Permit Type	Permit Number	Opened Date
Building/Residential/Addition/SFD	B23004826	12/13/2023

Description of Work
 SFD/ CONSTRUCT 1-STORY 8'-9" X 2'-6" SECOND FLOOR ADDITION (20 SQFT) & INTERIOR ALTERATIONS TO EXISTING. CONSTRUCT 13' X 8'-6" COVERED PORCH., 2 STORY, Part Crawl Space/Part Slab on Grade, 1R, 0FB, 0HB, 1FP, OTHER STRUCTURE = N/A, 0BR, PORCH/DECK = Open Porch and Deck, ENERGY METHOD = Prescriptive Method,

RE: Description of Single Family Dwelling addition and interior alteration of Building Permit
B23004826

From: Oswald Jr, Woodin
Sent: Thursday, December 21, 2023 9:21 AM
To: 'INFO@TRANSFORMINGARCHITECTURE.COM'
Subject: B23004826_3660 Daisy Road

SITE INSPECTION SHEET

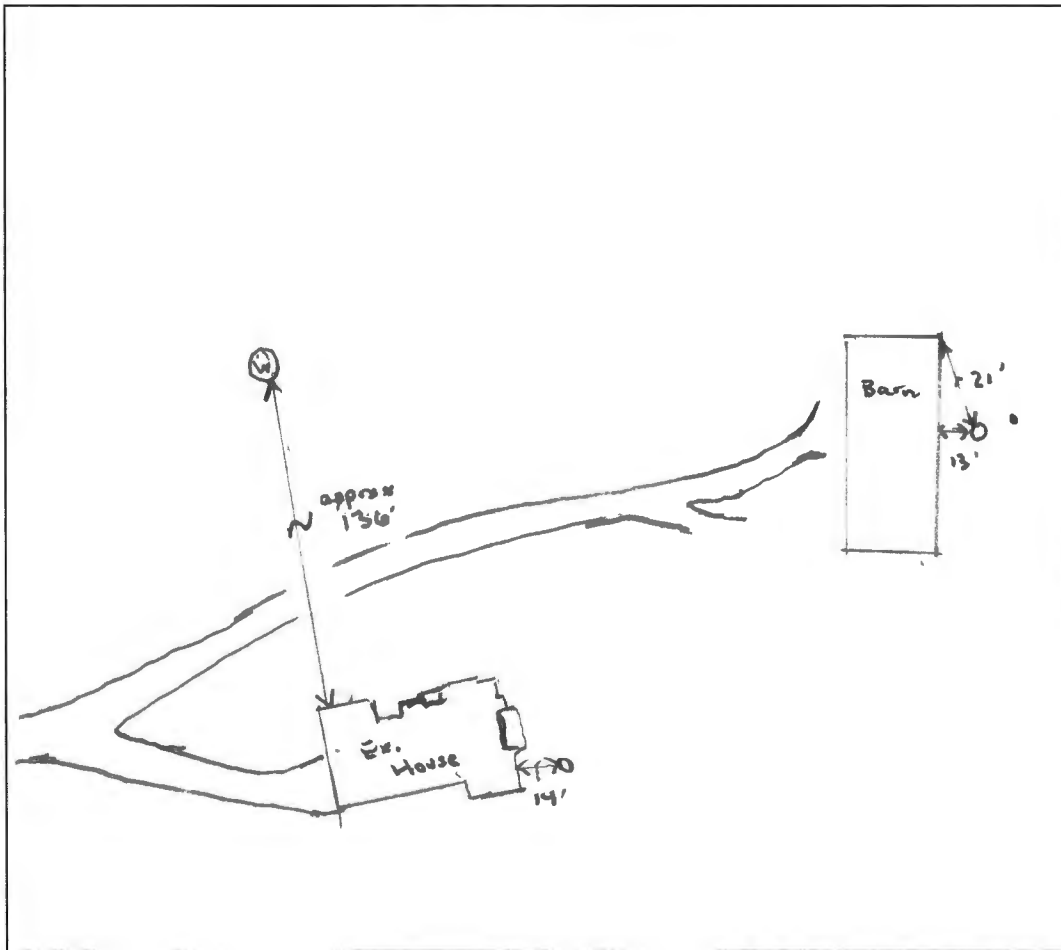
COMMENTS: No issues observed with the well or septic
system. Owner states that he has the tank
pumped 1x year if he hasn't had any issues.
